**ADDENDUM NO. 1**

Date: **April 15, 2024**

Project: **Project #: 0521-470  
West Campus HS Baseball/Softball Field Improvements**

**I IRRIGATION PIPE TRENCHING** NTS

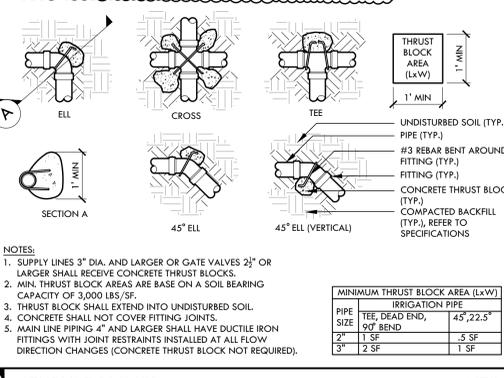
Q10: Is the intent of the new irrigation to include a 2-wire controller? If so, what size conduit should the wire be run in?

**A10: Intent is to use existing controller if possible. Contractor to provide allowance to install new controller. Contractor to confirm the following: if existing controller is 2-wire, the number of free stations, the number of stations that were removed from demo, and the existing stations to remain. 2-wire to be direct burial. If under pavement, 2-wire to be placed inside irrigation sleeving. Sleeving size varies per mainline size. See Detail I/D6.1 (updated D6.1 attached).**

**DRAINAGE AND UTILITY PLAN - SOFTBALL & PARKING**

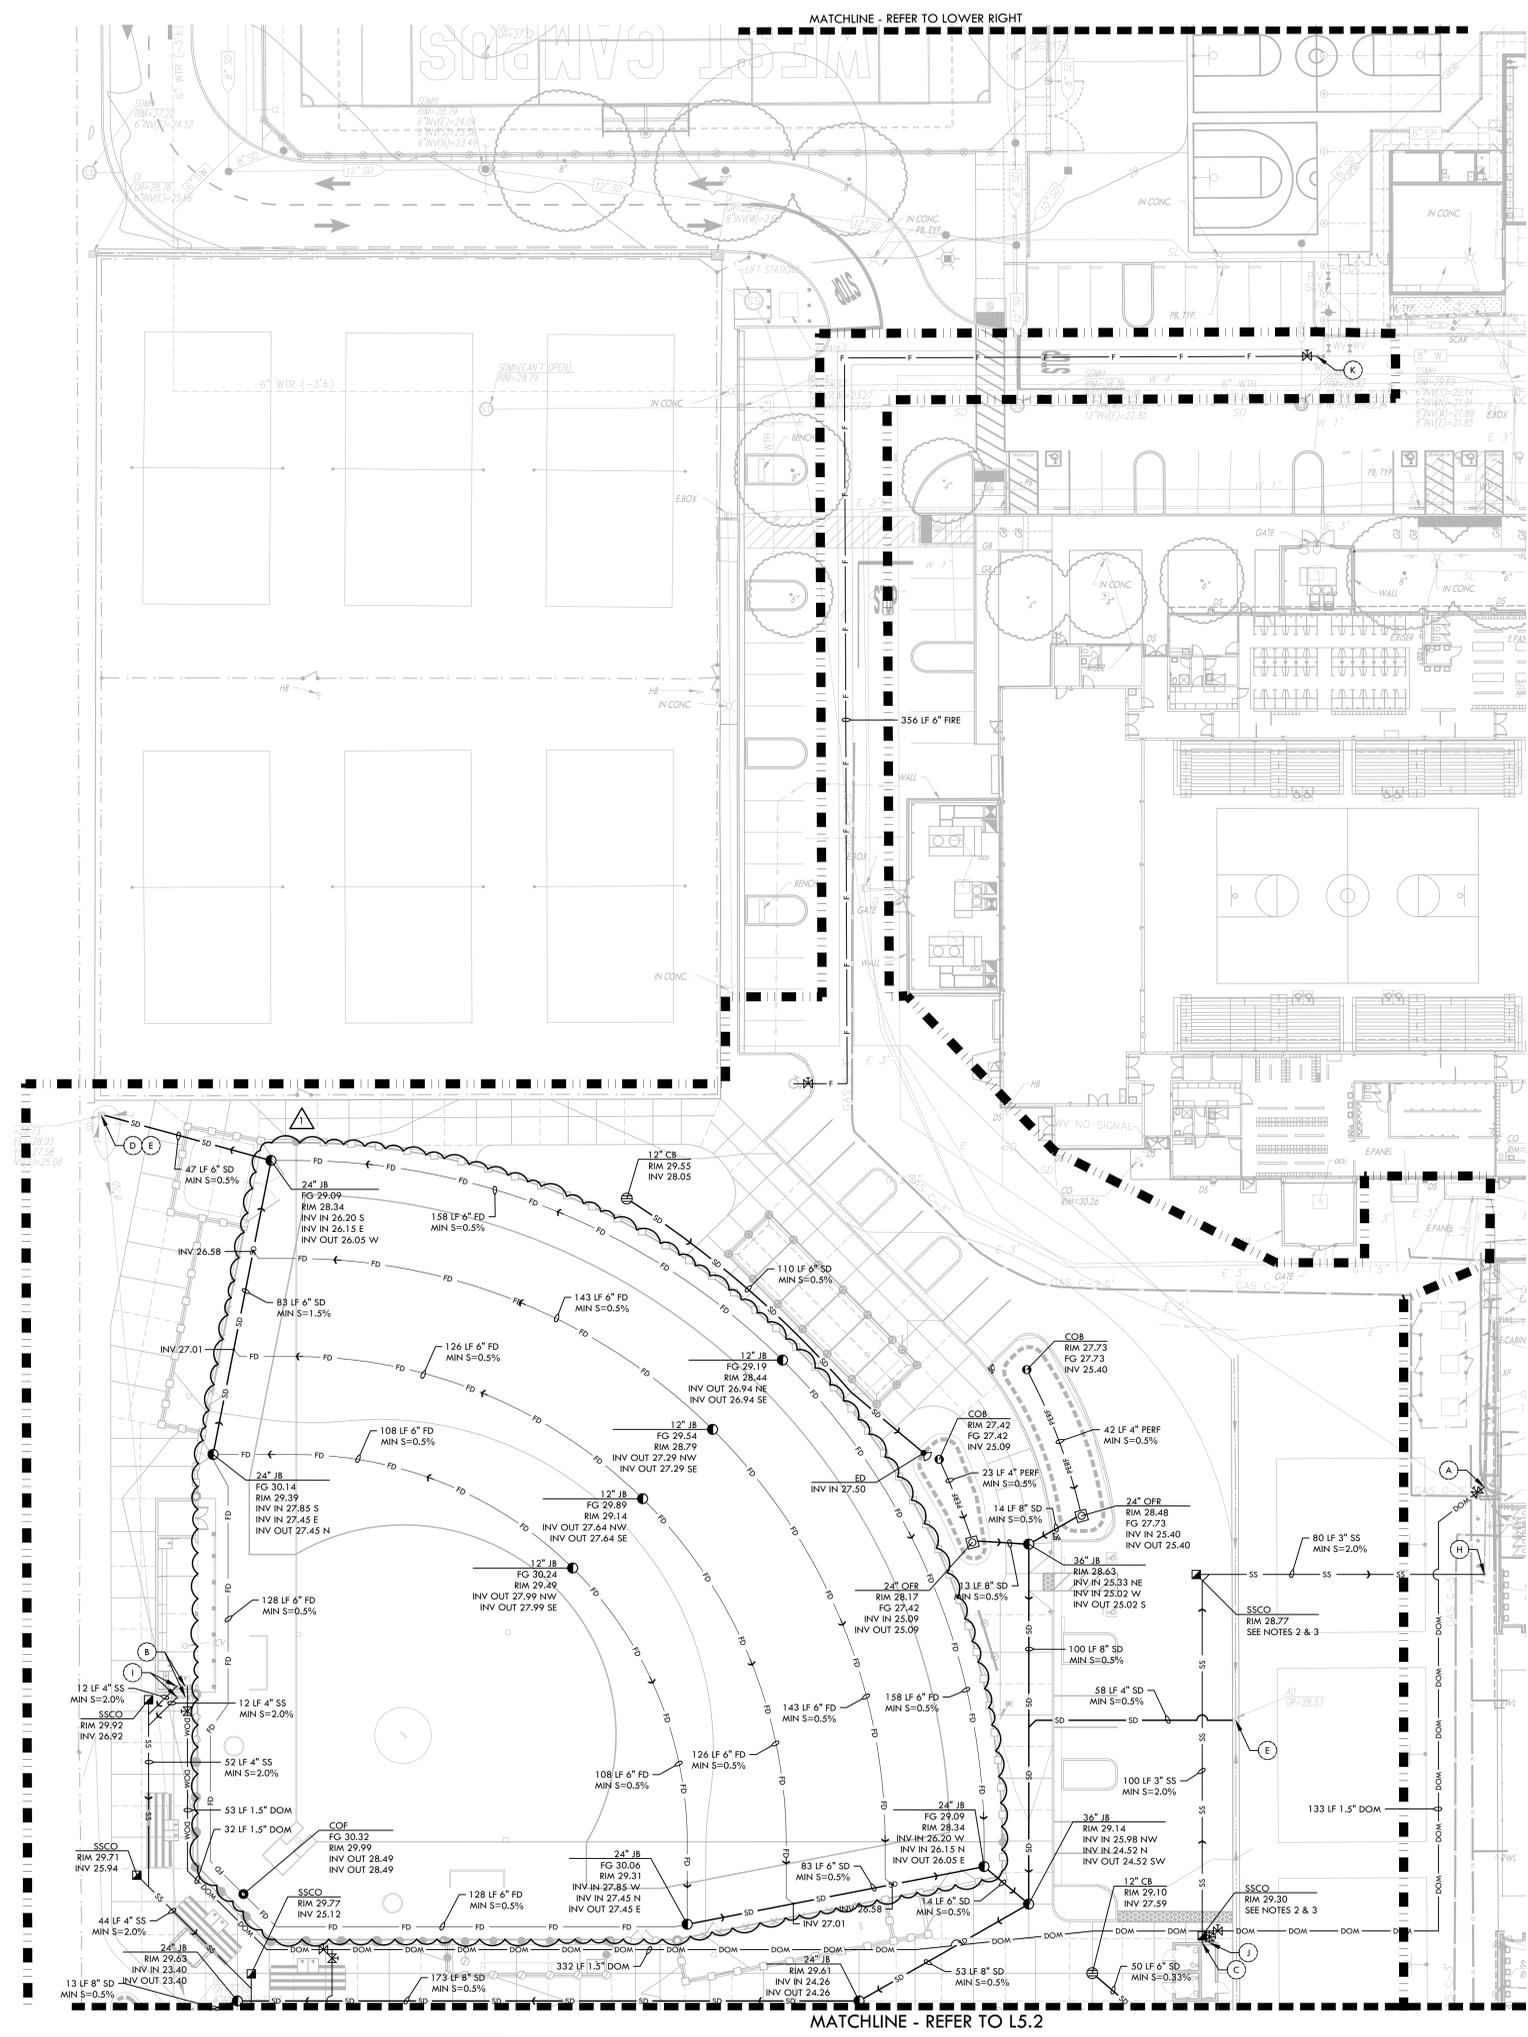
Q5: Sheet L5.1 shows an additive alternate french drain on the legend and plans, but there is only 1 additive alternate including on the bid form. Please confirm whether all french drains should be included in the base bid.

**A5: All French drains are to be included in the base bid. Refer to updated plan sheets L5.1 & L5.2.**

**L5.2**

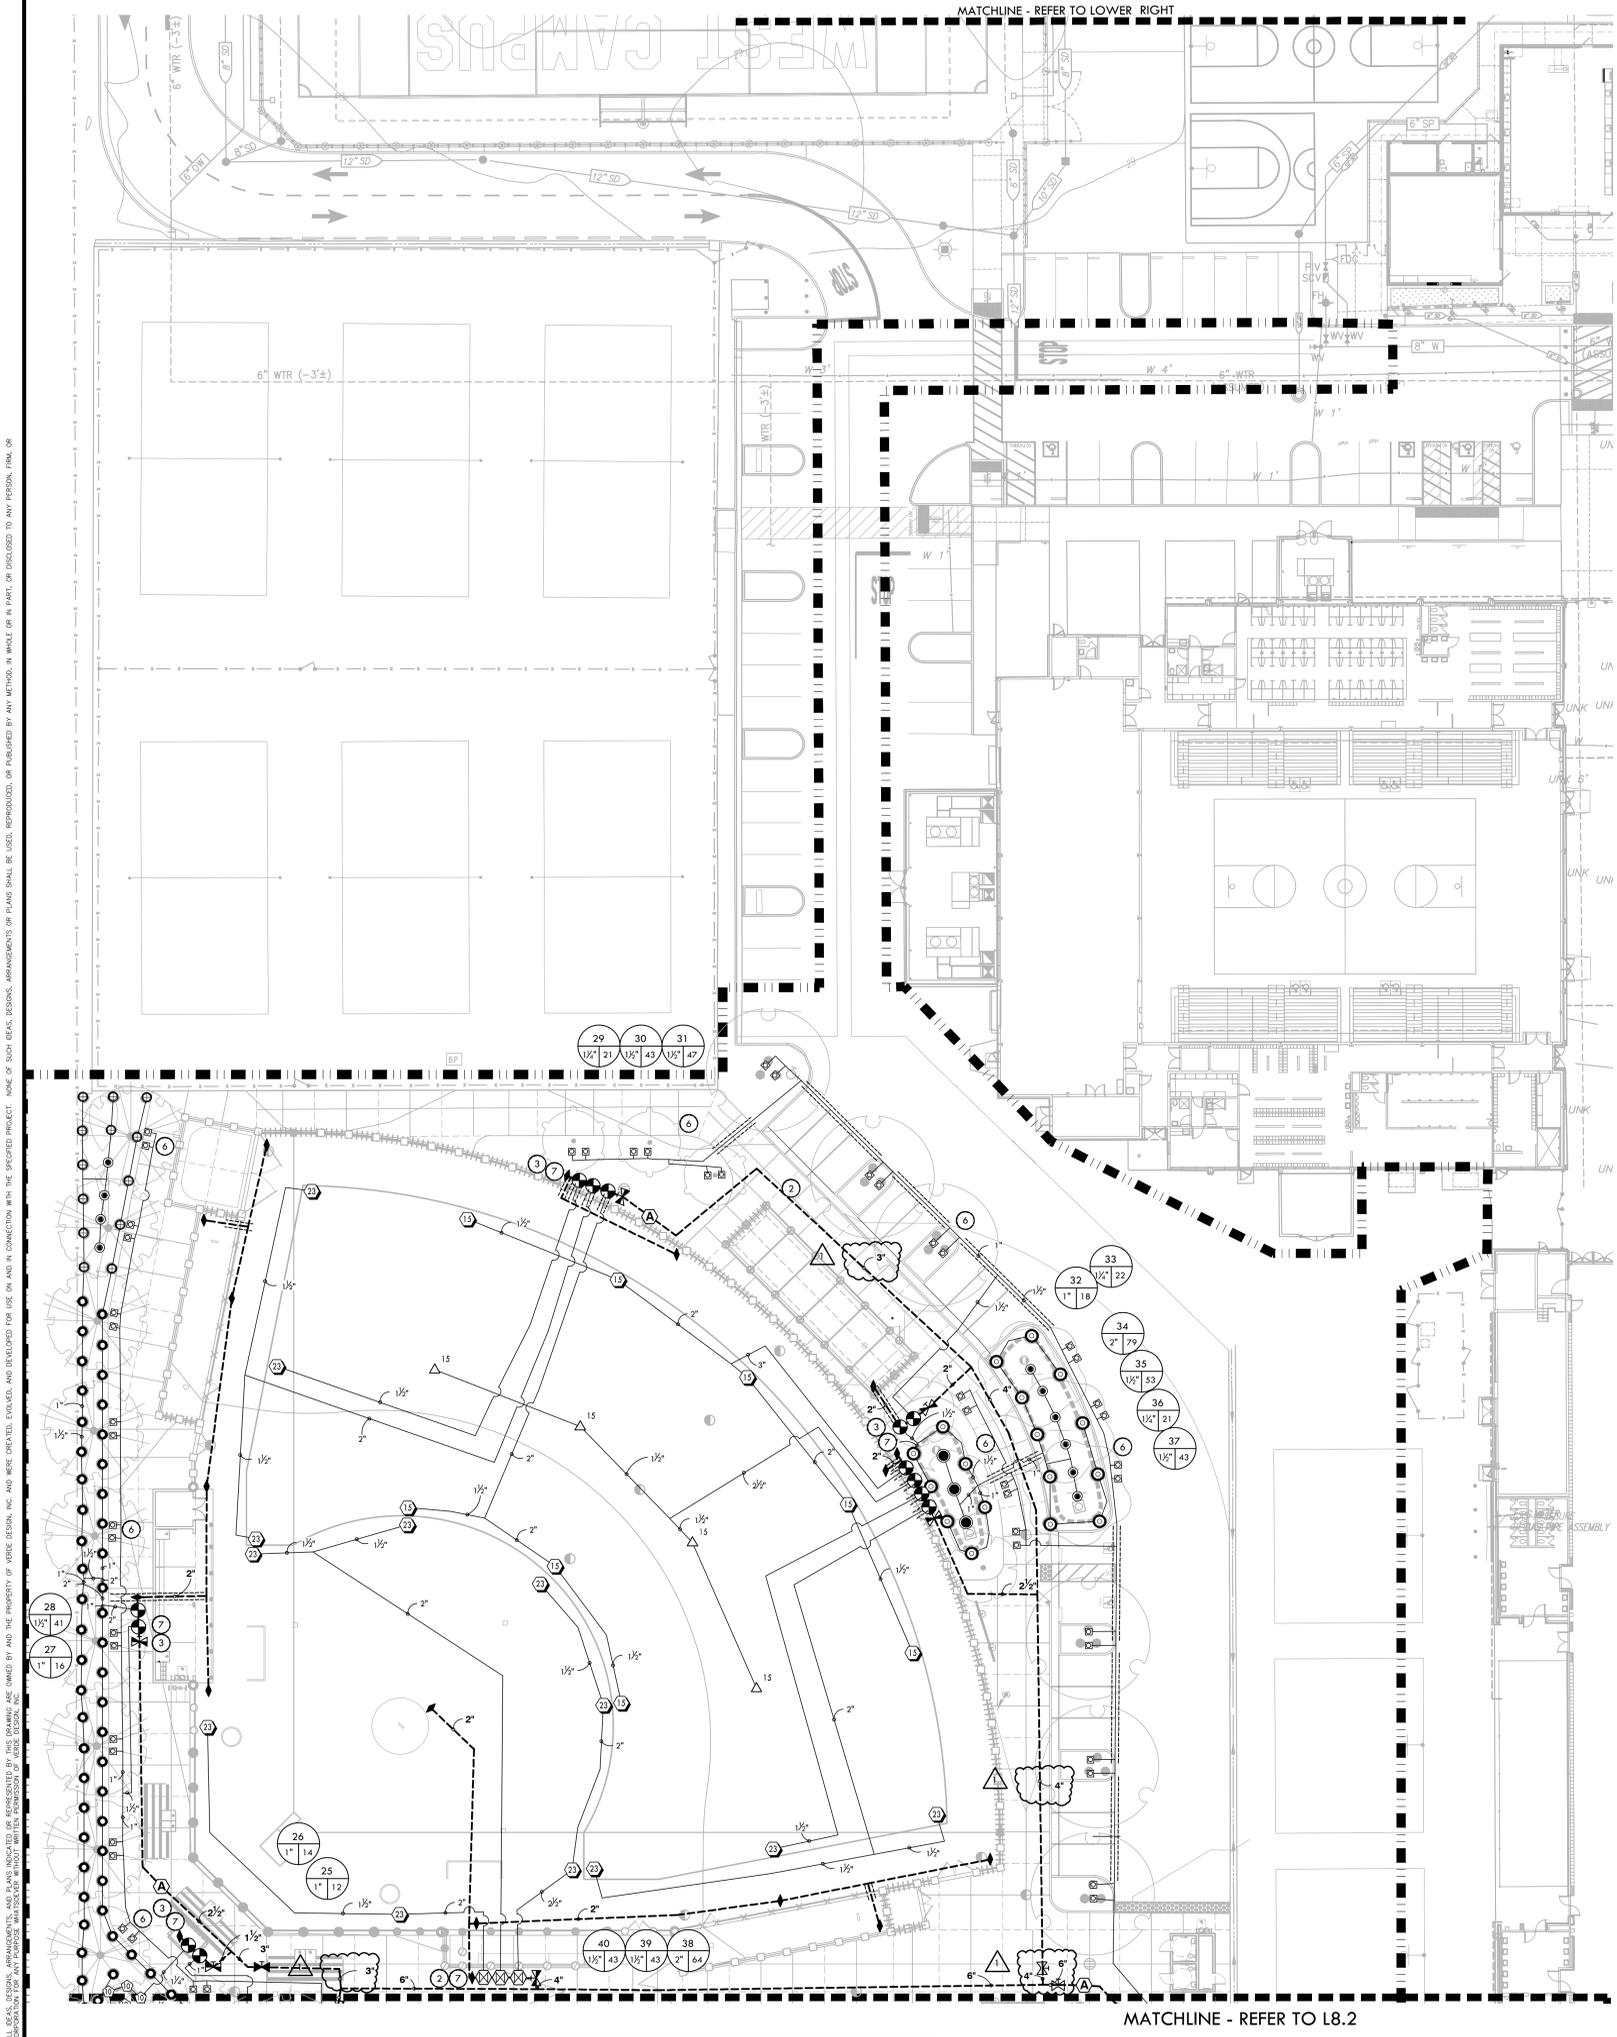
Q9: Sheet L5.2 shows relocated (e) gas line to match size and material. Please confirm what size and material we should assume at bid time.

**A9: Existing information is unknown. Contractor shall verify per sheet note 9, "9. PRIOR TO ALL DRAINAGE AND UTILITY WORK, CONTRACTOR SHALL BE RESPONSIBLE FOR VERIFYING ALL POTENTIAL DRAINAGE CONNECTIONS AND EXISTING UTILITY BY POTHOLES. IN ADDITION, ALL DOWNSTREAM CONNECTIONS TO EXISTING STRUCTURES SHALL BE THE START OF THESE OPERATIONS, AND GRADES SHALL BE VERIFIED."**

SHEET NO.: **L8.1**

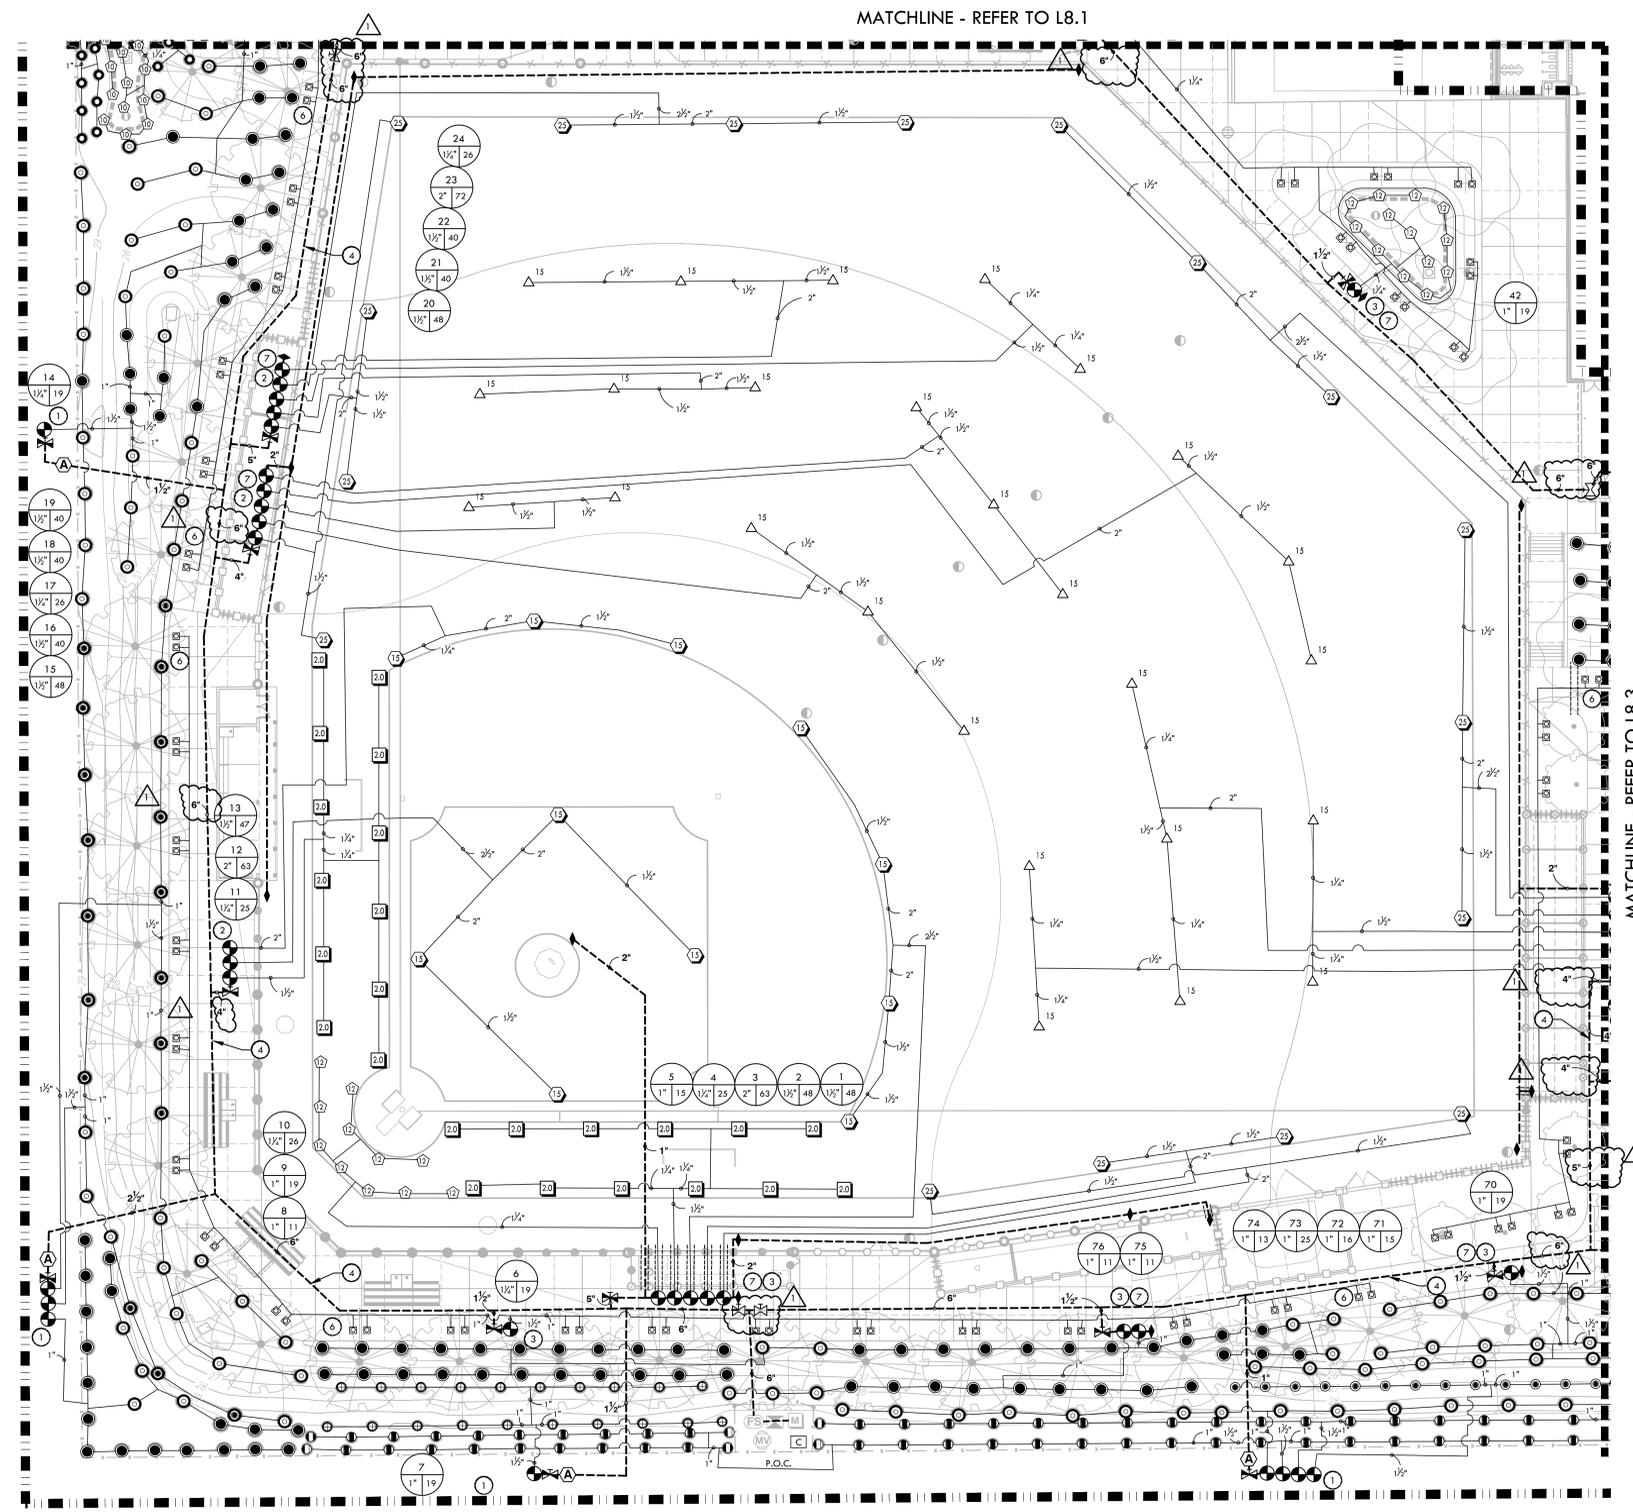
Q6: Please provide irrigation mainline sizing on sheet L8.1 from the bottom SE corner of the page traveling north to the parking lot. Not enough information to price this out.

Q28: There are some parts of mainline that have no size callout. Please clarify.

**A6: Refer to updated plan sheets L8.1-8.3 for mainline labeling and other updates.**

**A28: See updated irrigation plan for clarification.**
